HISTORIC AND DESIGN REVIEW COMMISSION

HDRC CASE NO: 2022-382
ADDRESS: 1024 DAWSON ST
LEGAL DESCRIPTION: NCB 1371 BLK 3 LOT E 38 FT OF 14
ZONING: RM-4, H
CITY COUNCIL DIST.: 2
DISTRICT: Dignowity Hill Historic District
APPLICANT: mark flinn/FLINN MARK
OWNER: mark flinn/FLINN MARK
TYPE OF WORK: Construction of a 2-story, rear accessory structure
APPLICATION RECEIVED: August 23, 2022
60-DAY REVIEW: Not applicable due to City Council Emergency Orders
CASE MANAGER: Edward Hall

Historic and Design Review Commission
Design Review Committee Report

1 SITE PLAN

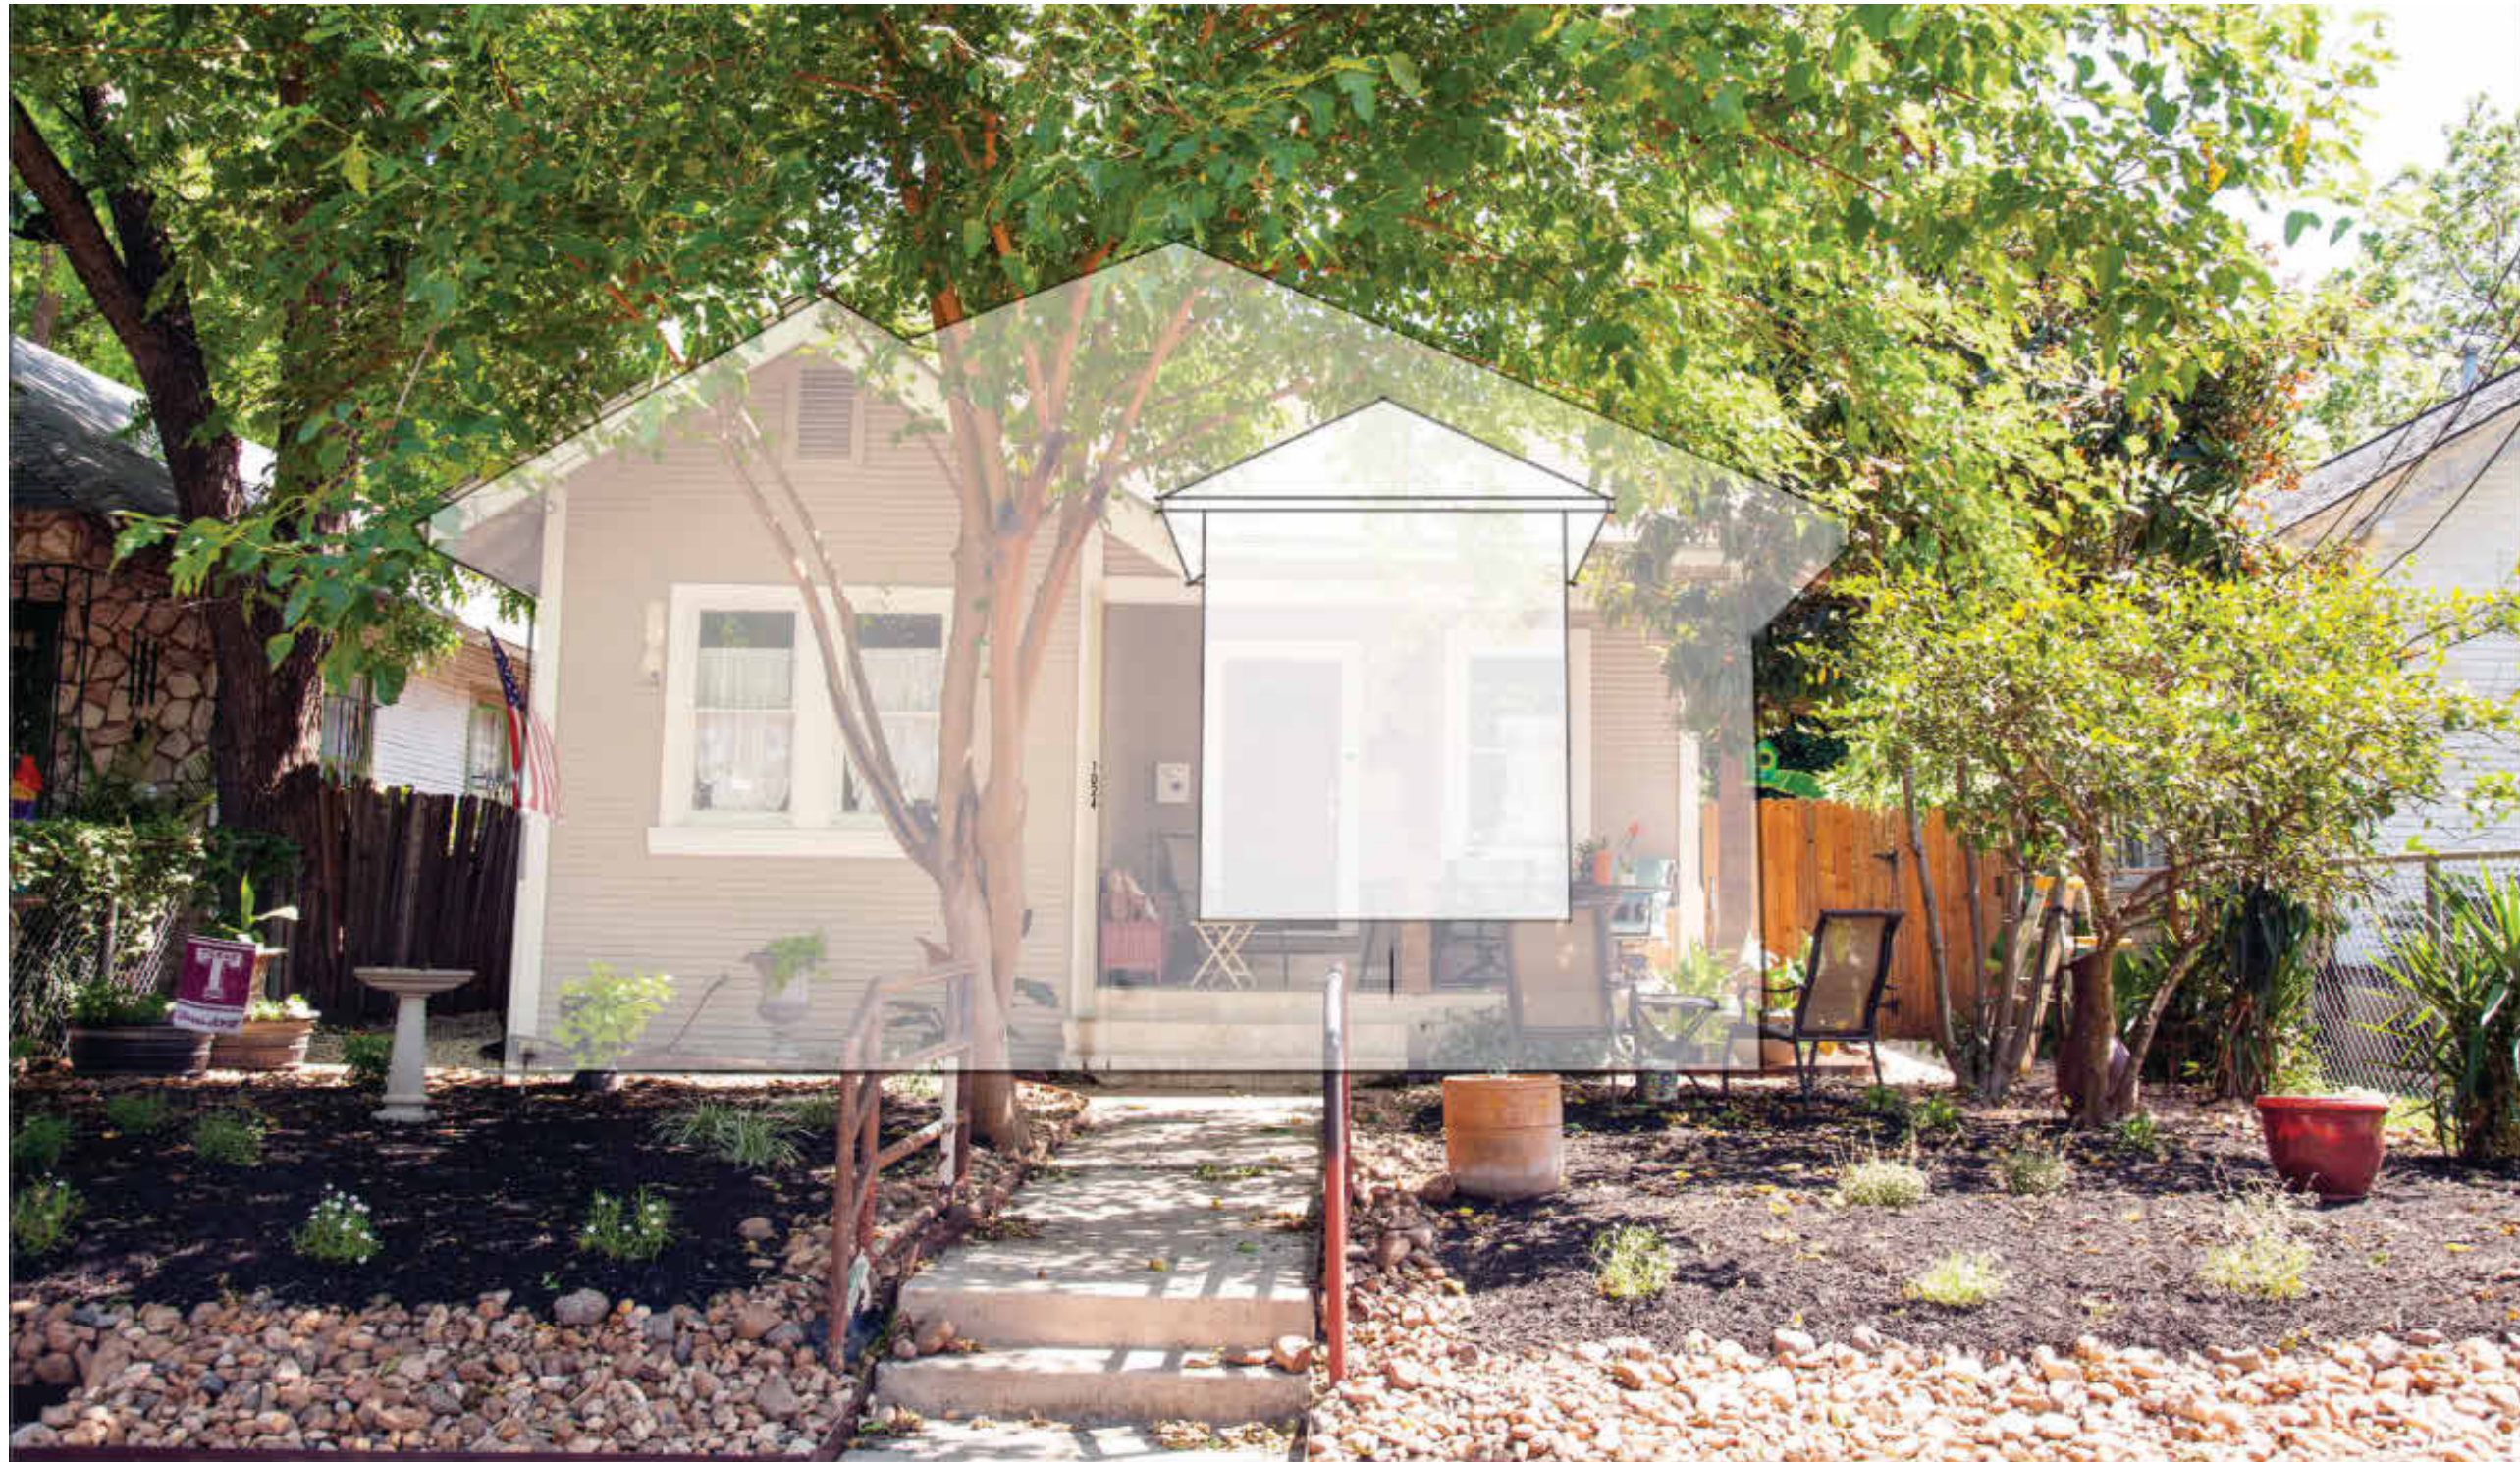
- g. **ORIENTATION & SETBACK** – The Guidelines for New Construction 5.B. notes that the predominant garage orientation and historic setback patterns of the block should be followed. Generally, staff finds the proposed location, orientation and setbacks associated with the proposed accessory structure to be appropriate.

MS: Questions regarding parking for the primary structure, questions regarding any thoughts of sub-dividing the lot.

MS/MF: Discussion regarding rear setback, increase in setback to provide for more space between the door and rear fencing.

JC: The site plan should include all site elements; fencing, landscaping elements, parking elements, walkways, etc.

JC: Questions about gravel driveway elements, and landscaping. How will the gravel be maintained? Will other landscaping elements be included?

MF: Site plan will be updated to accurately note site conditions and building location.

2 NORTH ELEVATION
SCALE: 3/8" = 1'-0"

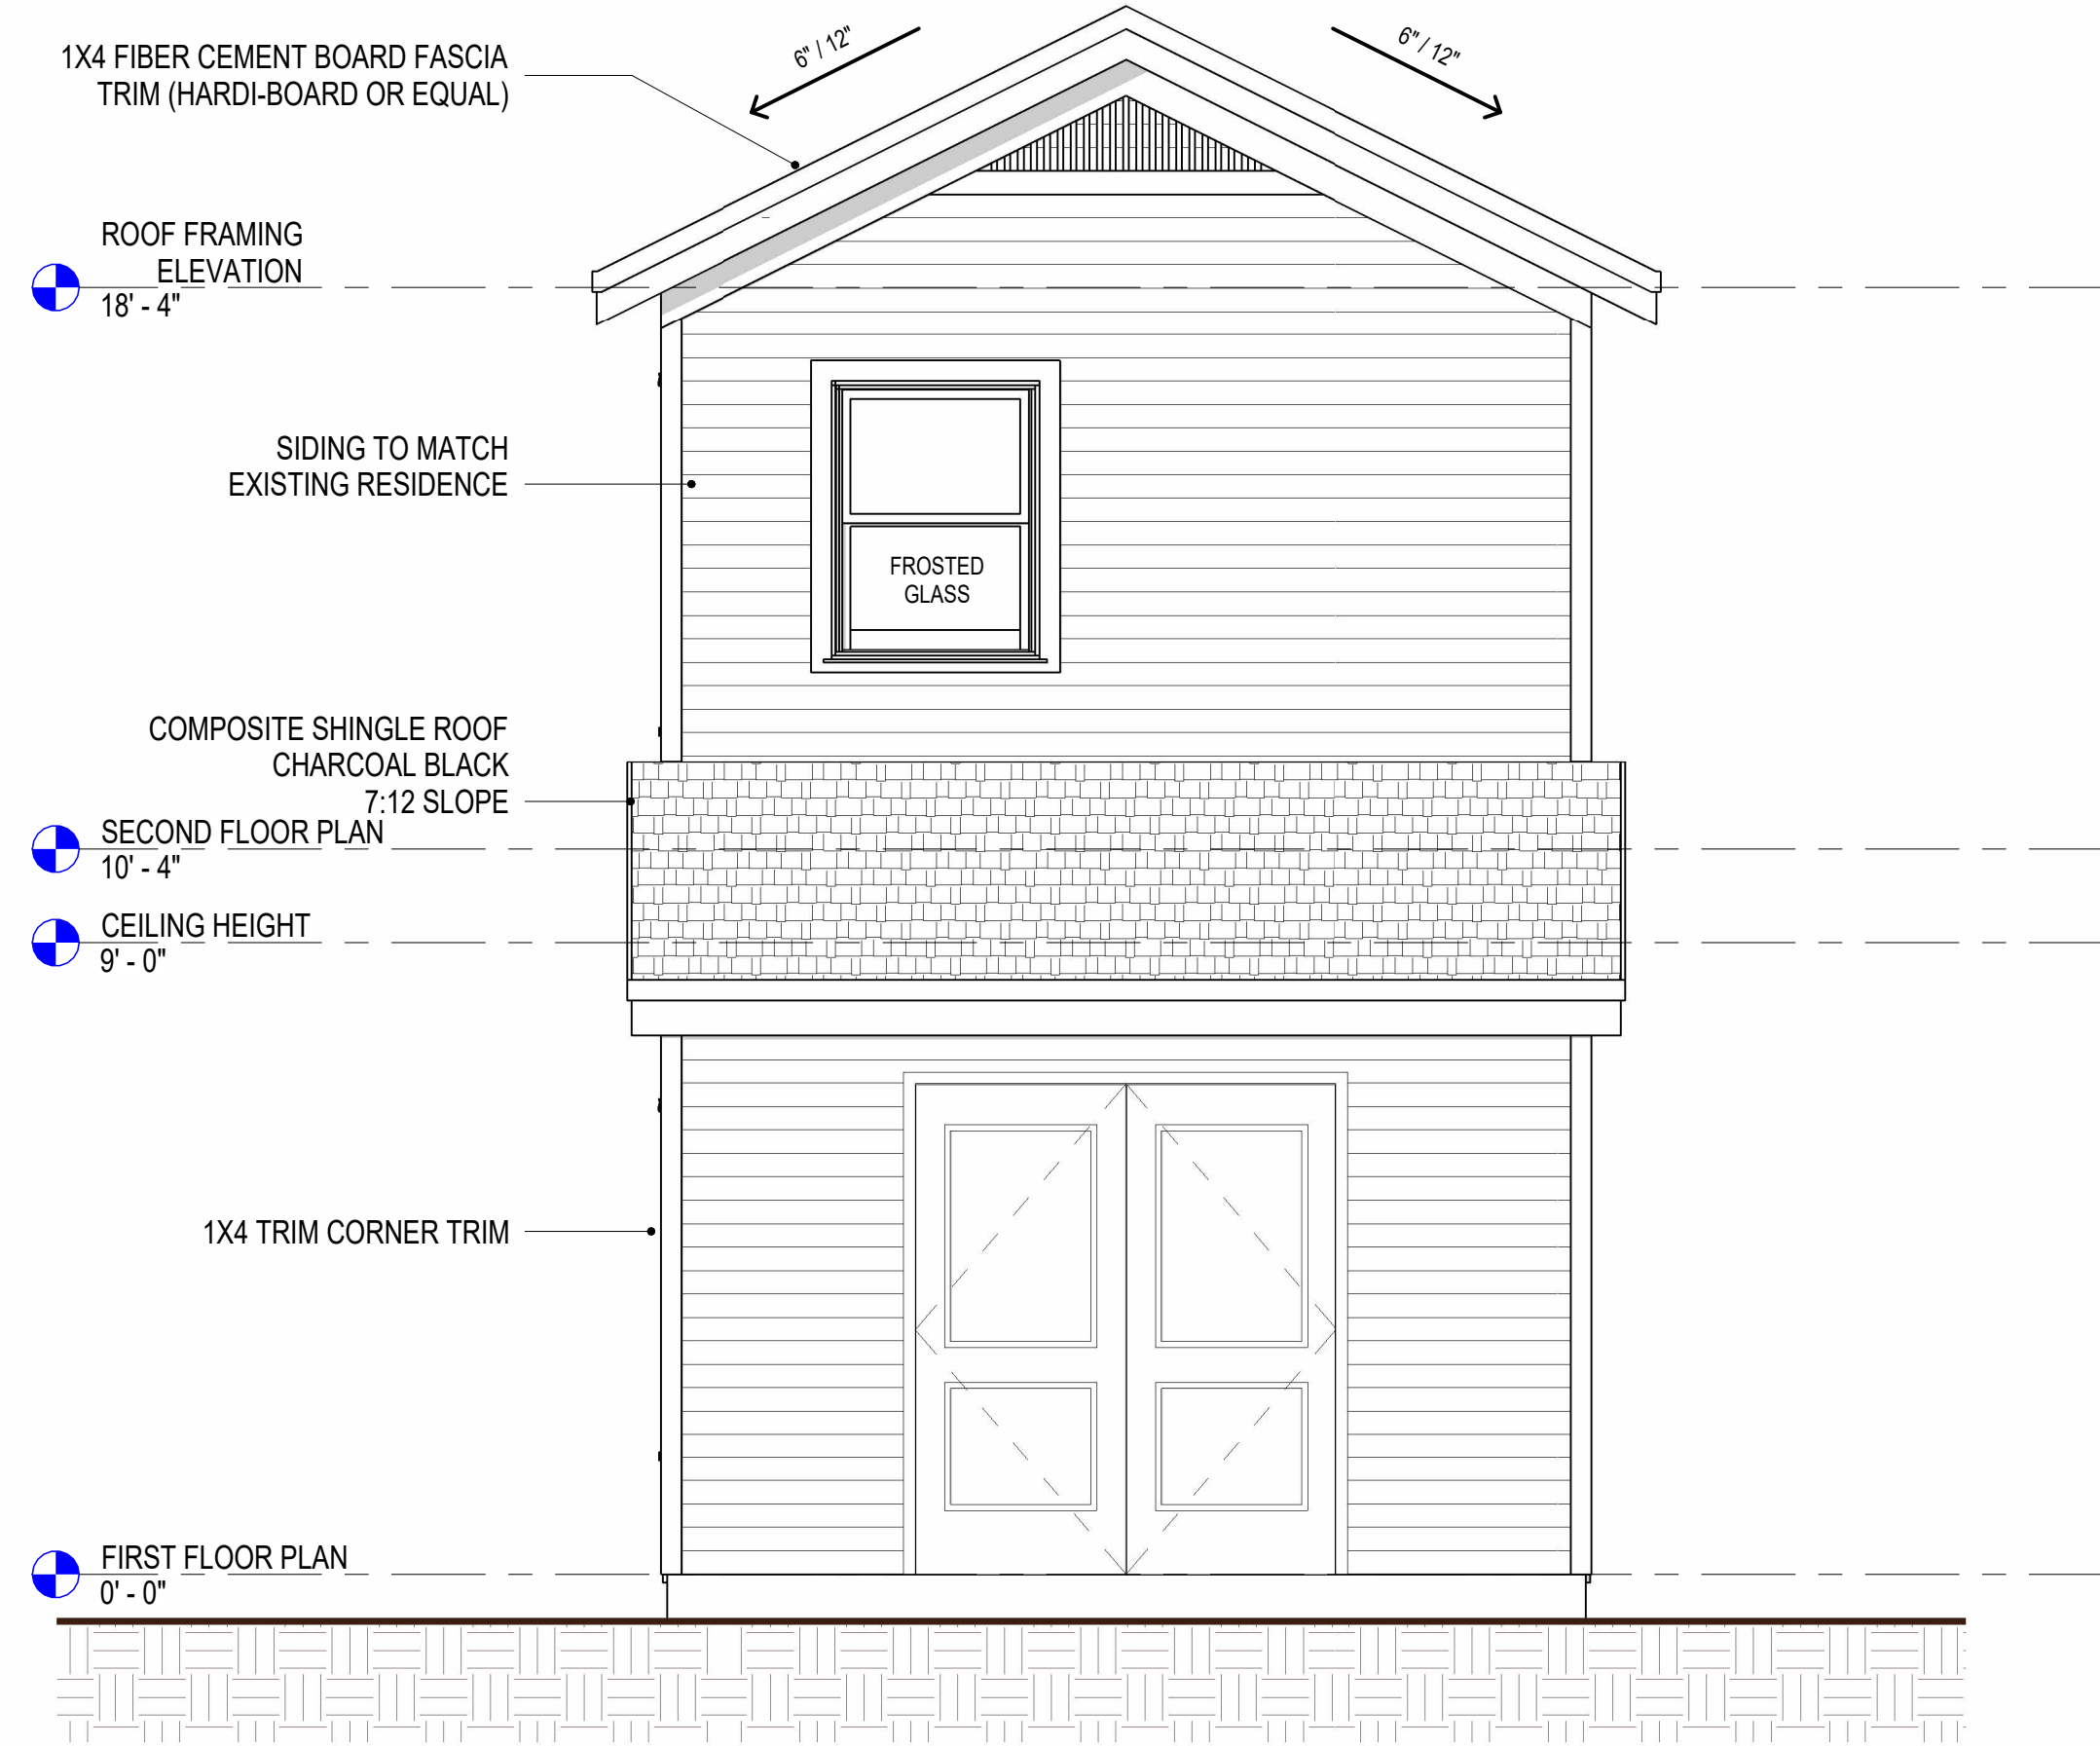
- ii. That all windows feature sash profiles, and that fenestration should be added to both the south and east elevations, which are currently either void of fenestration, or feature large, unseparated wall planes. Additionally, staff recommends that windows on the proposed accessory structure should feature profiles and sill details that are consistent with those of the primary historic structure on the lot.

MS: Recommends the installation of a window in the north façade. Recommends the incorporation of a porch facing the rear alley. Finds the overall reduction in height to be appropriate.

LG: The revisions are more appropriate for the historic district. Consider making the porch a bit deeper to feature approximately 5 feet in depth. Agrees with MS that a window should be added to the north façade on the second level.

1 FRONT ELEVATION
SCALE: 3/8" = 1'-0"

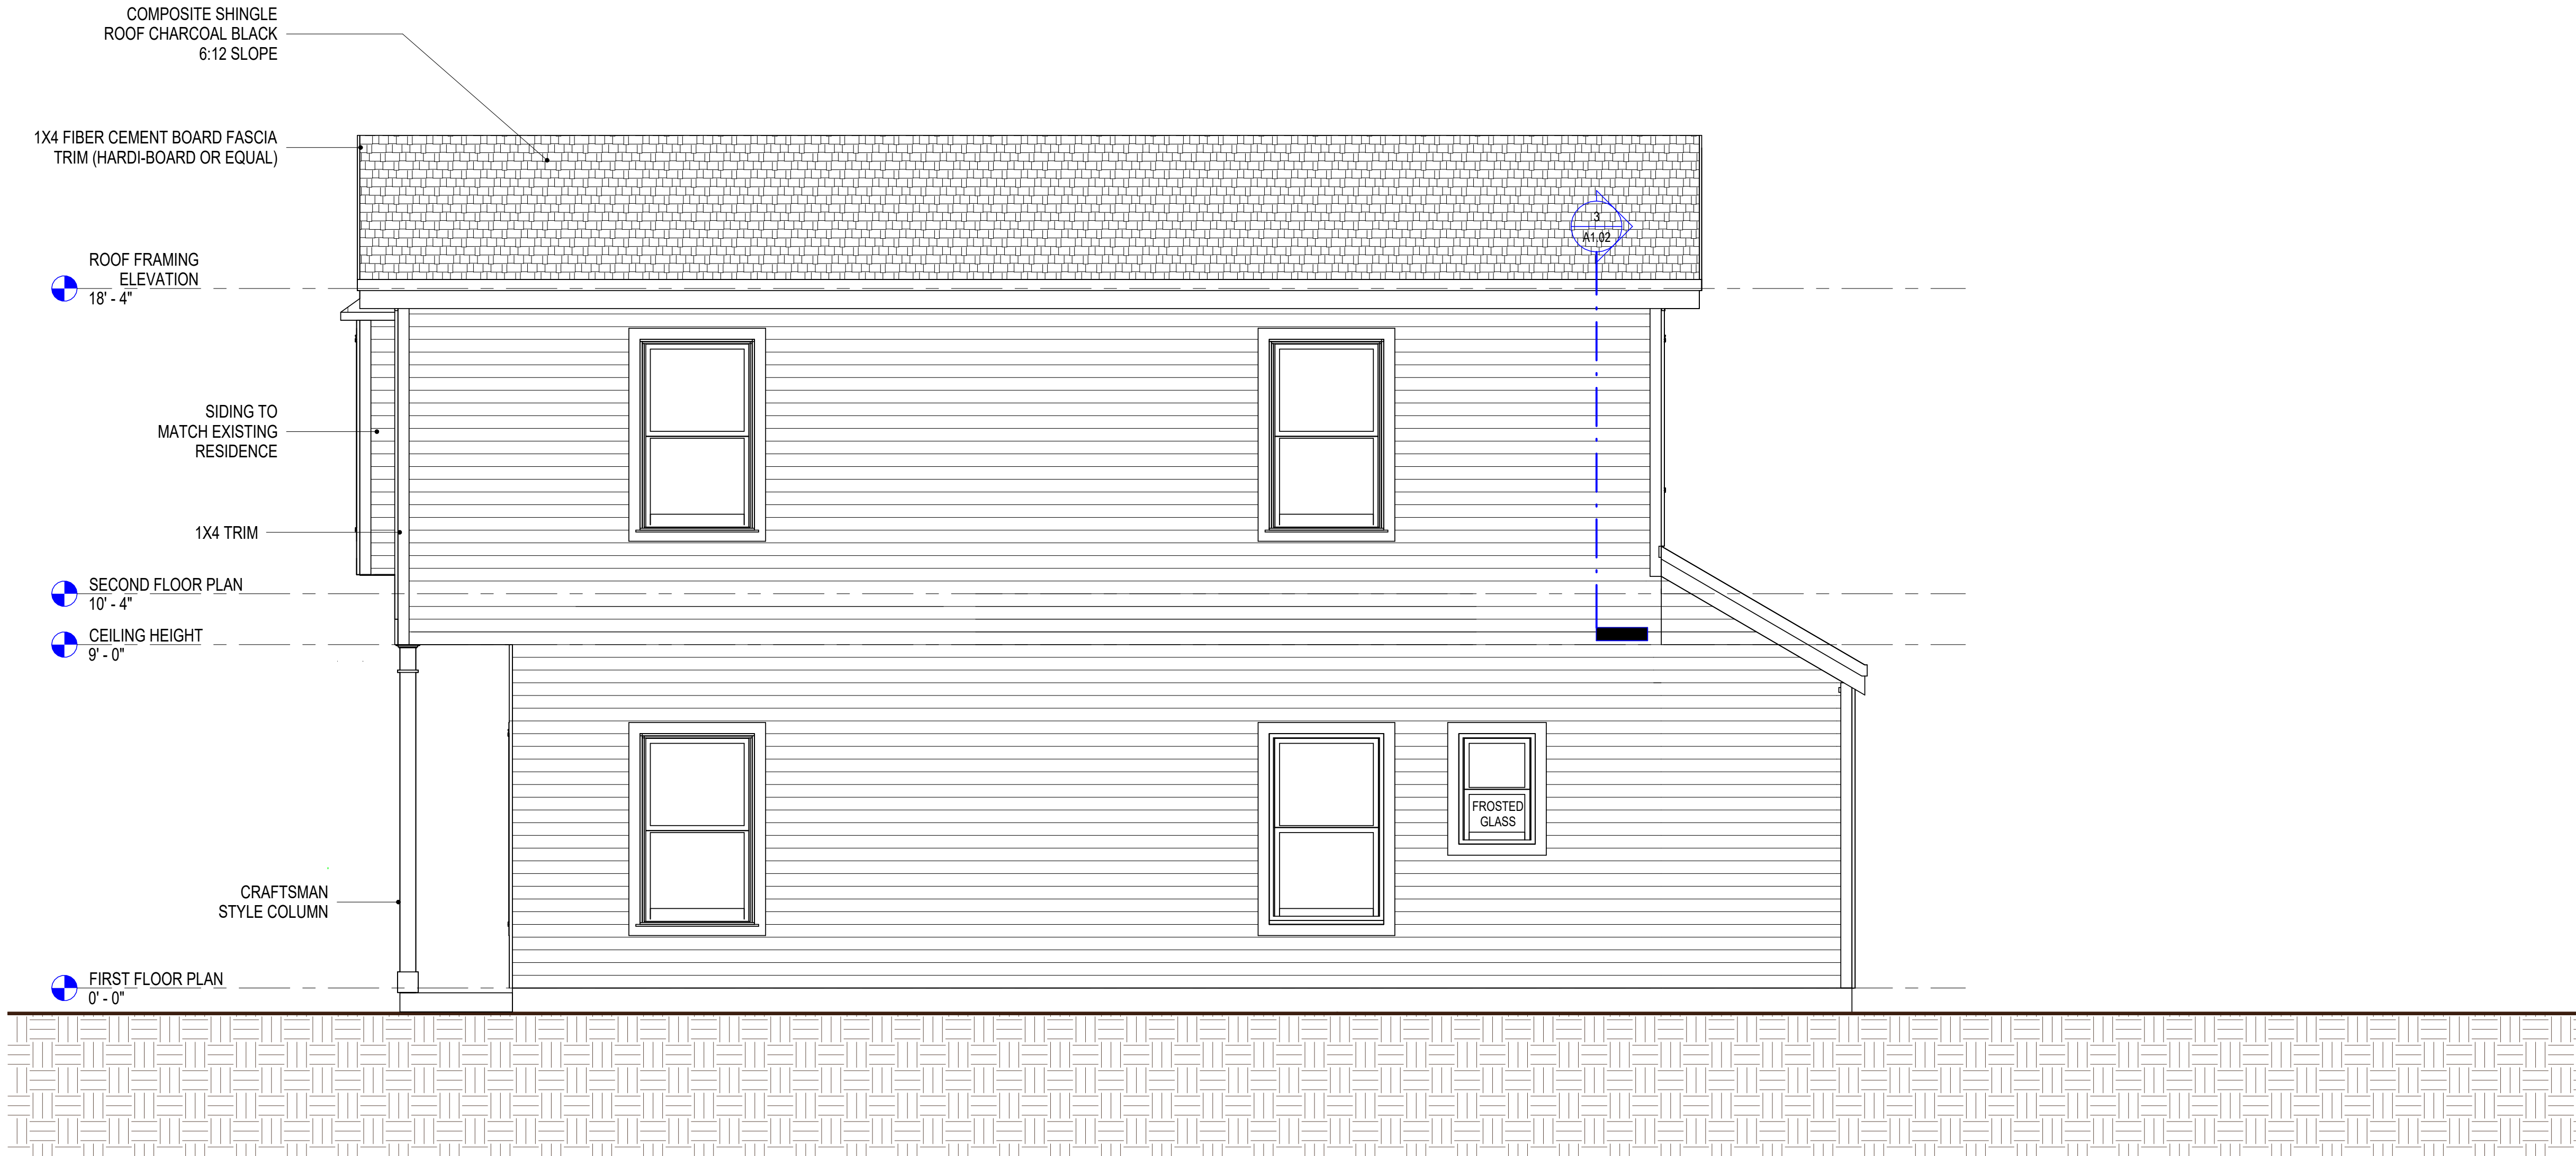
- i. CHARACTER – The applicant has proposed a cantilevered profile facing the right of way at Dawson Alley. Generally, the proposed form is not found historically within the district; front porches with porch massing and detailing are, however. Staff finds that the applicant should incorporate traditional porch massing rather than cantilevered roof forms.
- j. WINDOW MATERIALS – At this time the applicant has not proposed a specific window product. Staff finds that the applicant should install wood or aluminum clad wood windows that are consistent with staff's standards for windows in new construction.

JC: Incorporate a porch into the design; Dawson Alley. MF: The revised porch design will include a porch with porch elements.

JF: Increase the porch depth; at least five (5) feet in depth. Incorporate appropriate columns and other porch detailing. Front door location should not matter (center or side). If on the side, consider a pair of windows.

- i. That the applicant revise the Dawson Alley design to feature a traditional porch element rather than a cantilevered element, as noted in finding i.
- ii. That the applicant install wood or aluminum clad wood windows that are consistent with staff's standards for windows in new construction, as noted in finding h and in the applicable citations.
